**PROCUREMENT SERVICES
ADDENDUM**

Date of Notice:	1/22/2025
Solicitation No.:	IB-010-25
Title:	HSC Restroom Renovations
Addendum No.:	1

IB-010-25

Addendum 1

55B-103

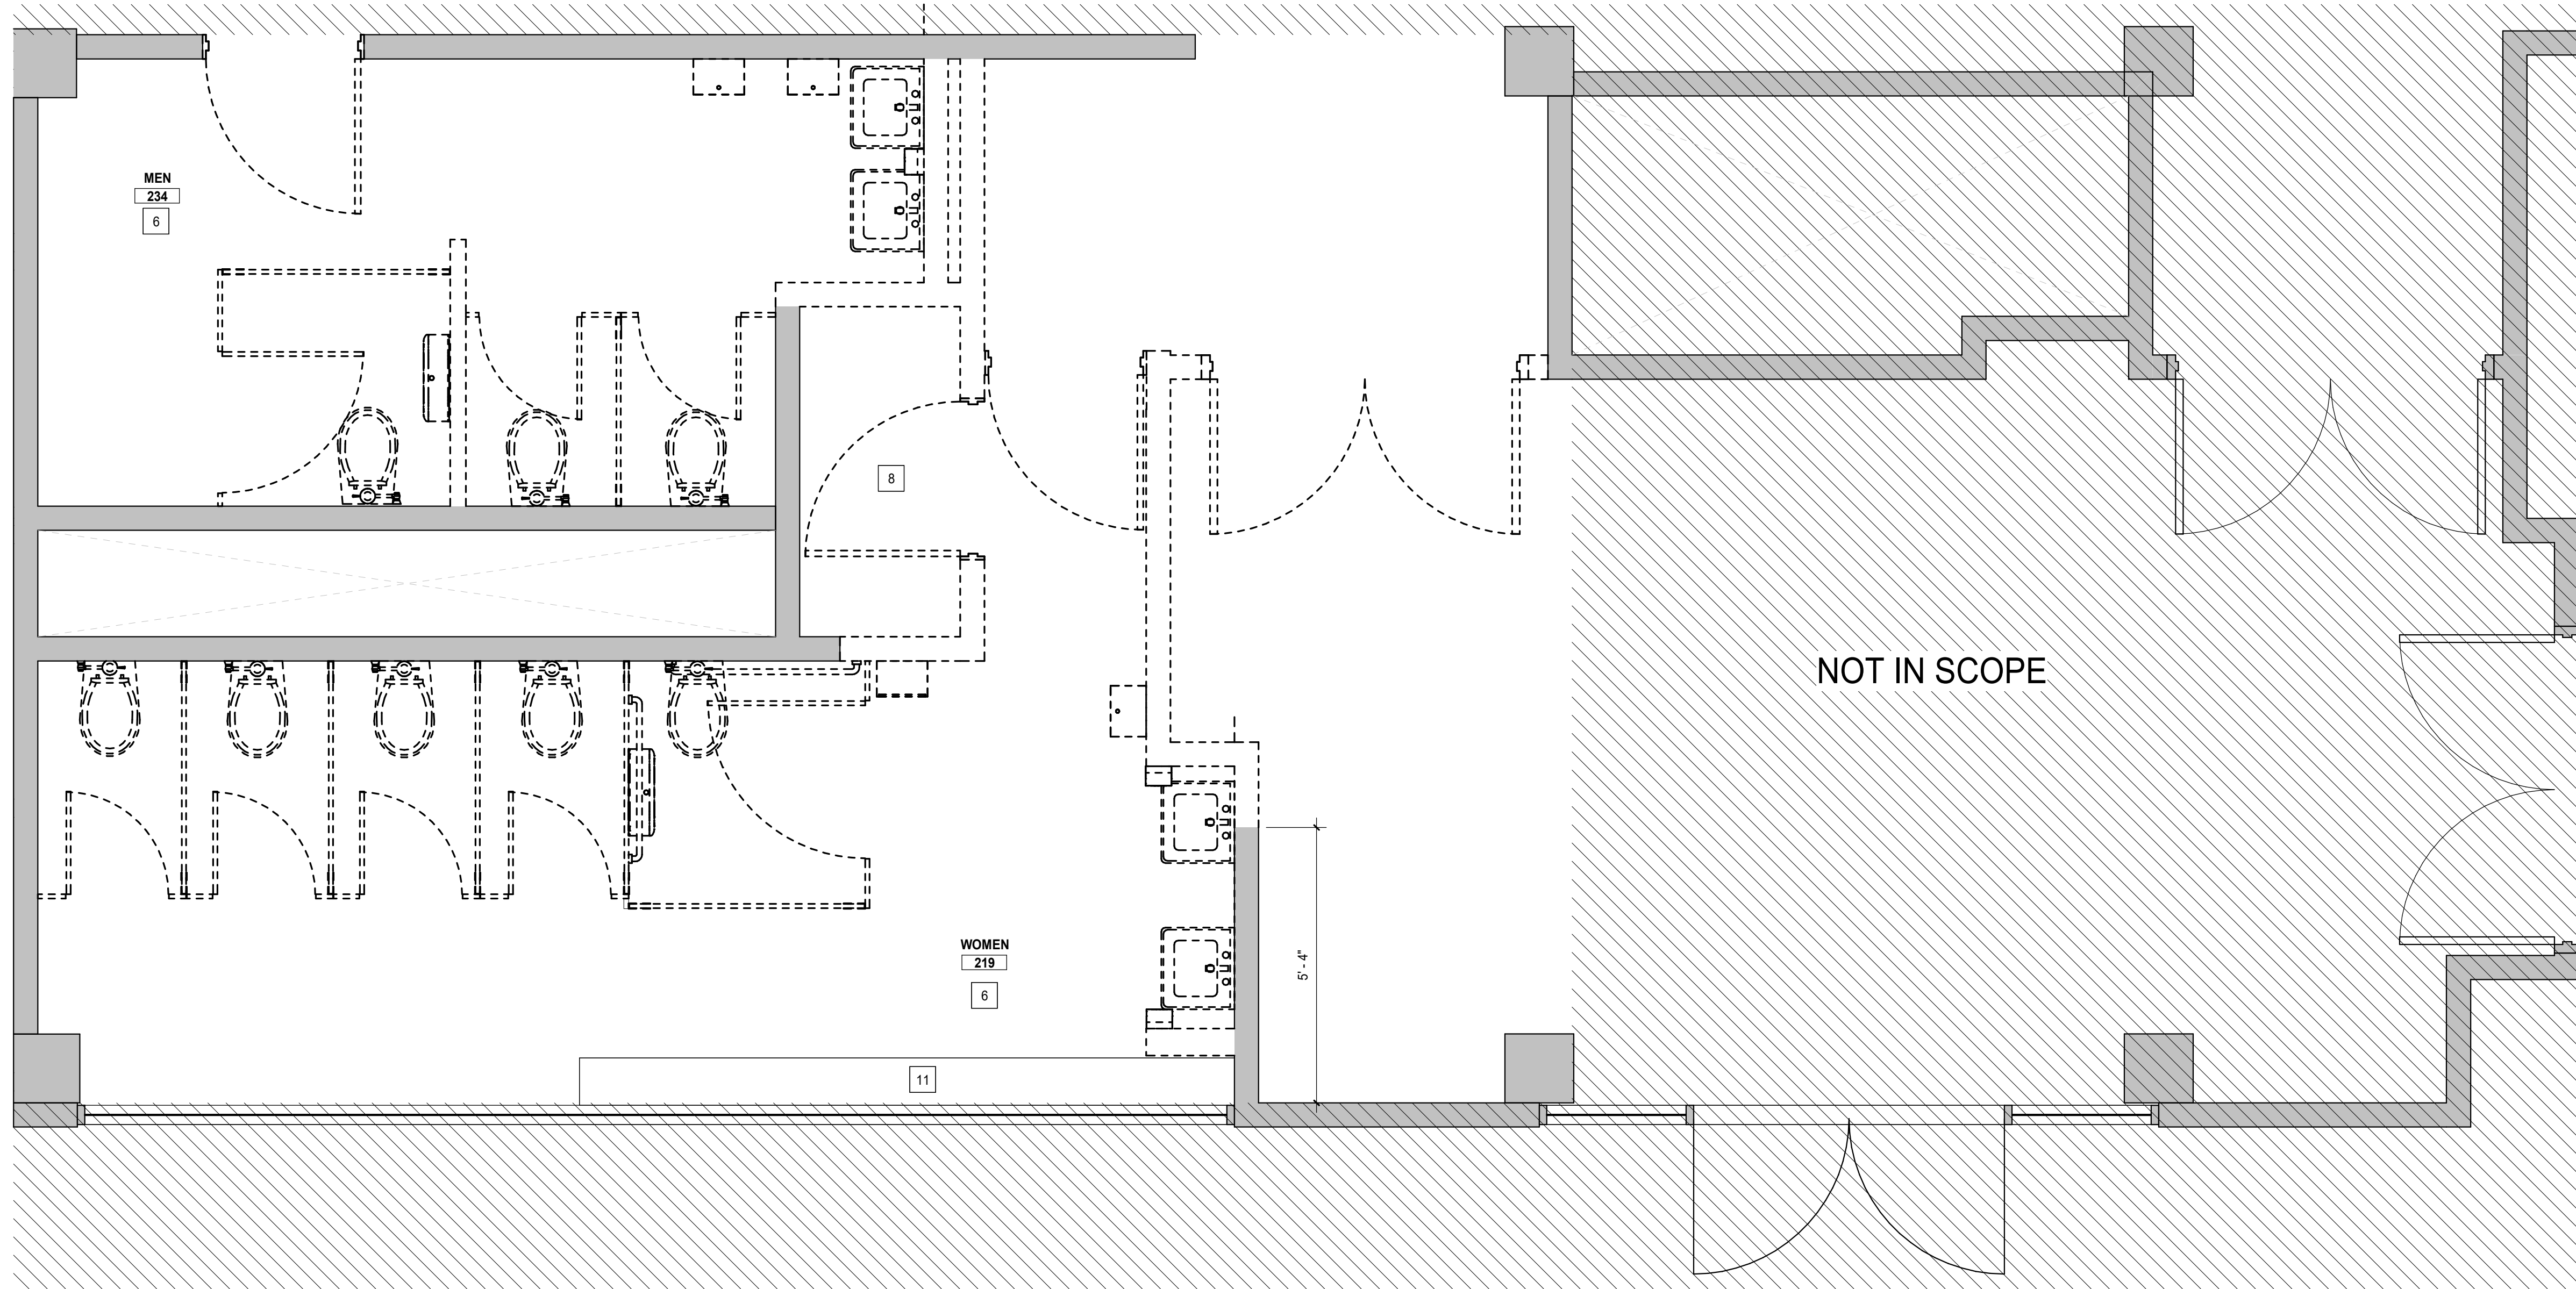
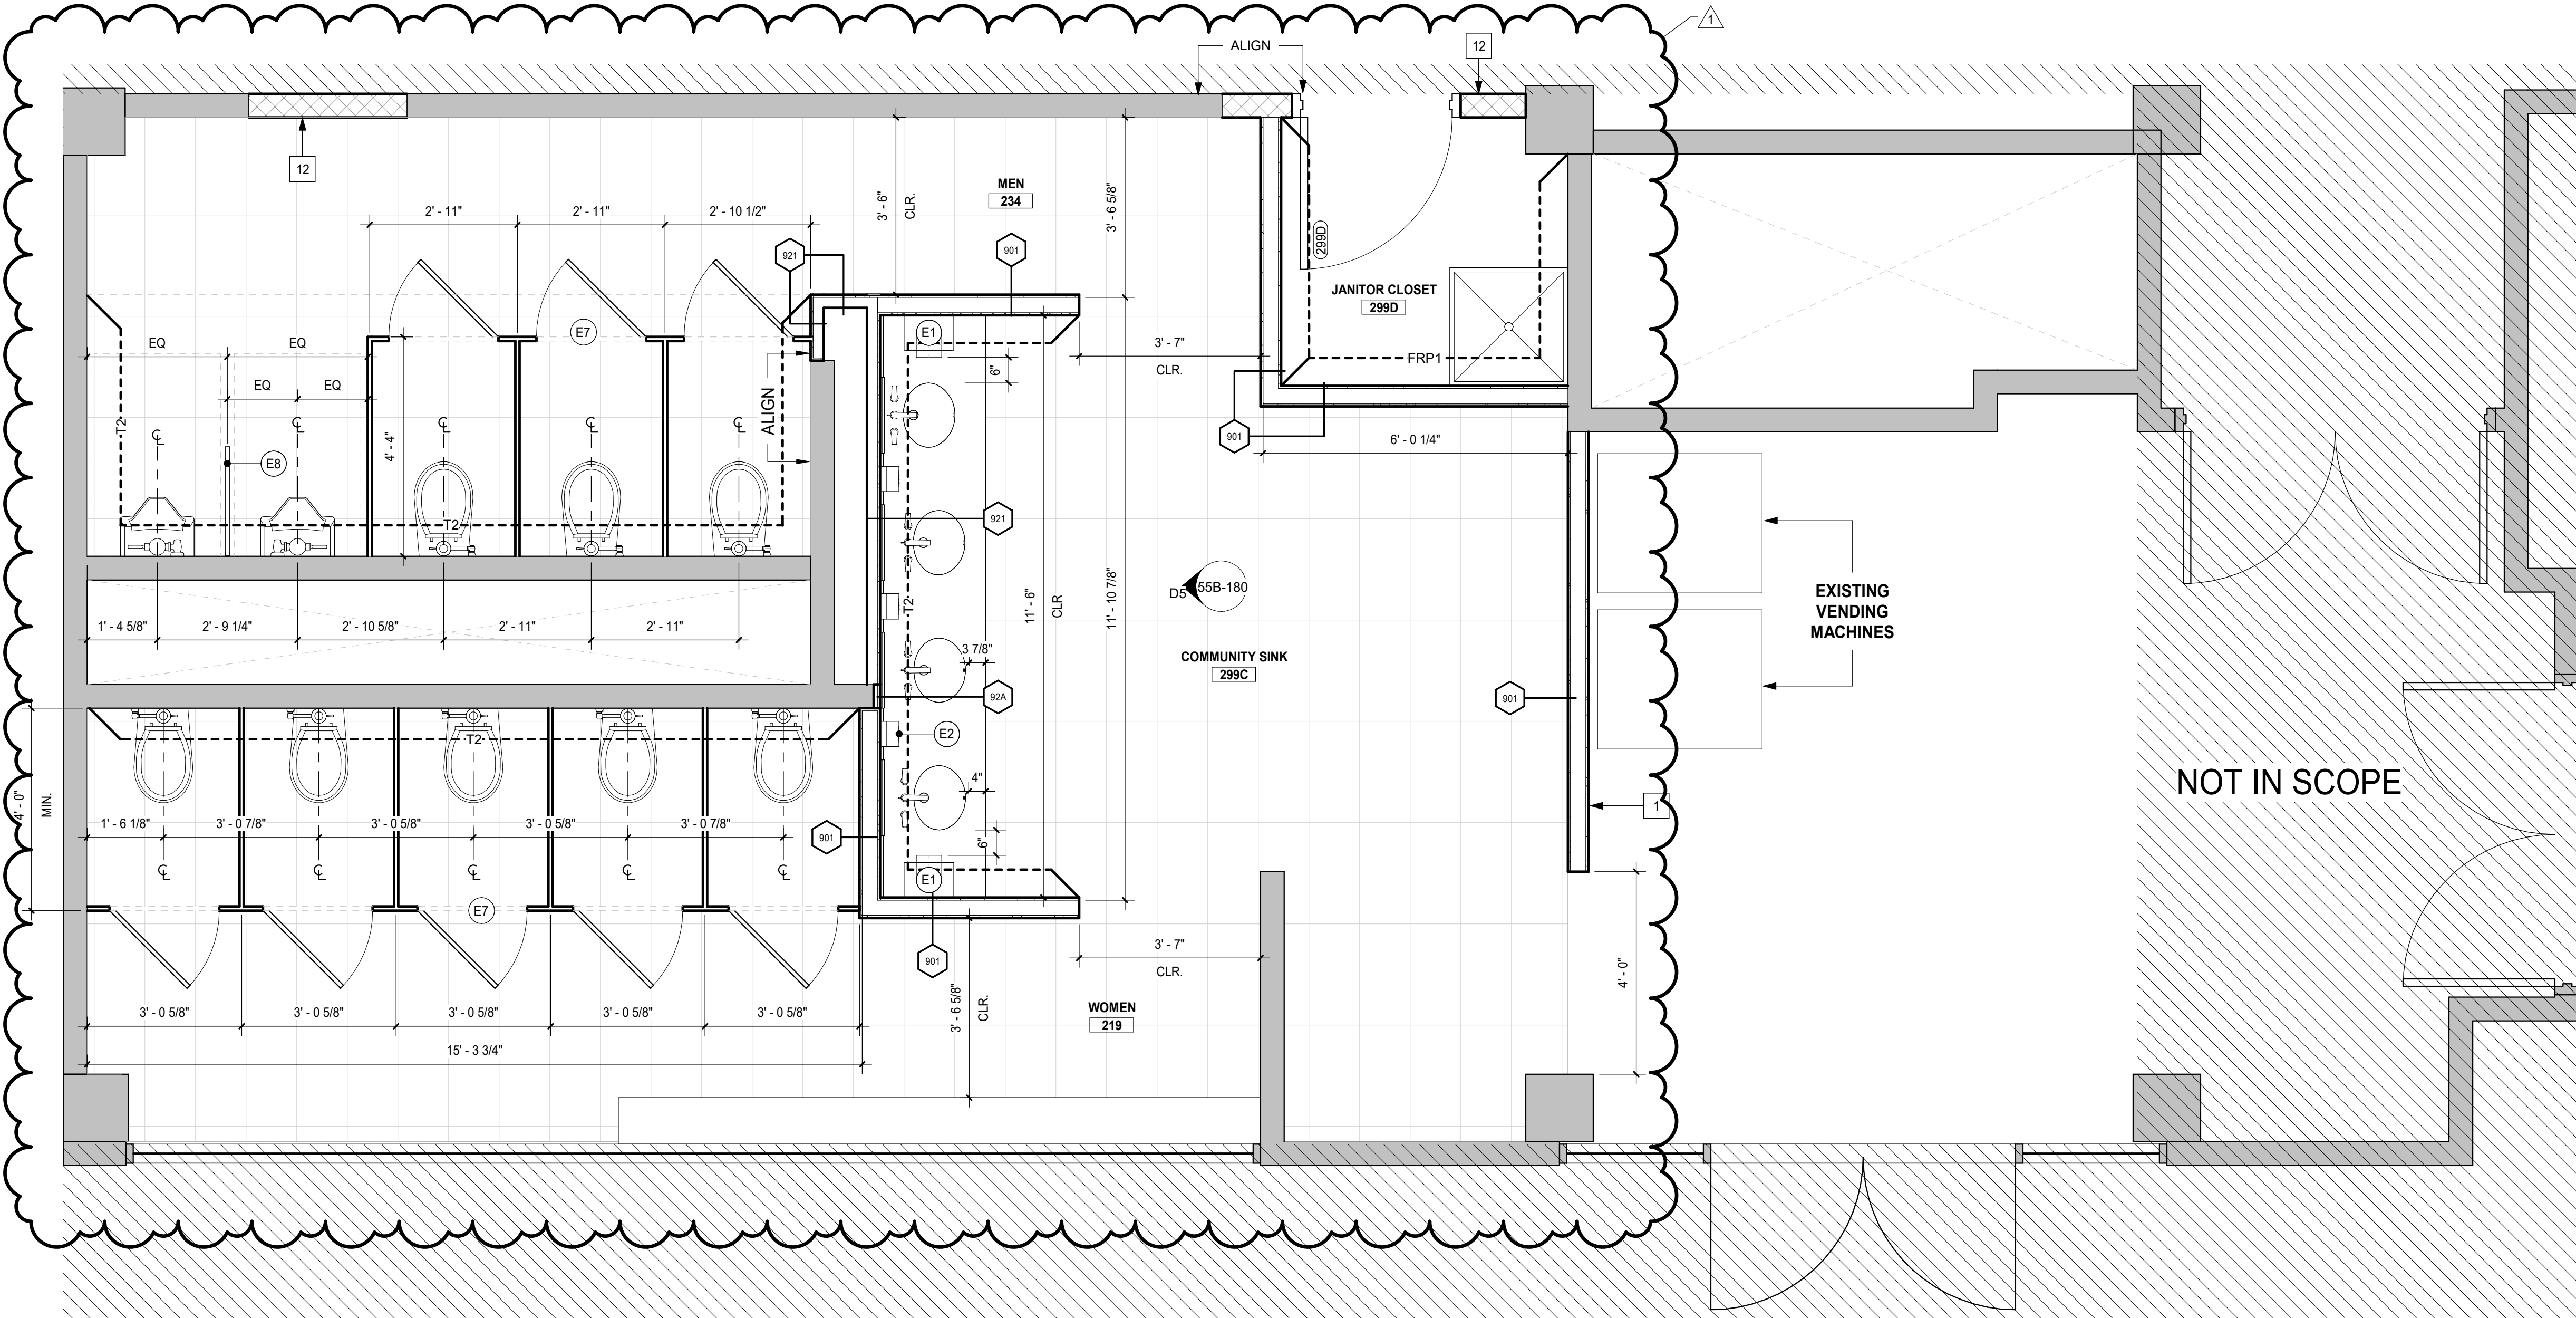
8. **Clarification Item 1:** Within the 55B 1st Floor scope, ceiling material has been updated. See **revised 55B-202** attached for clarification.
9. **Clarification Item 2:** Within the 55B 2nd Floor scope, flooring material is shown for scope clarity. Additionally, the door and mop sink location within Janitor Closet 299D have been updated. See **revised sheet 55B-103** attached for clarification.
10. **Clarification Item 3:** Within the 55B scope, Sheet Note 17 has been updated, see **revised sheets 55B-102 and 55B-103**.
11. **Clarification Item 4:** Within the 55A scope, Sheet Note 7 has been added, see **revised sheets 55A-101, 55A-102, and 55A-103**.
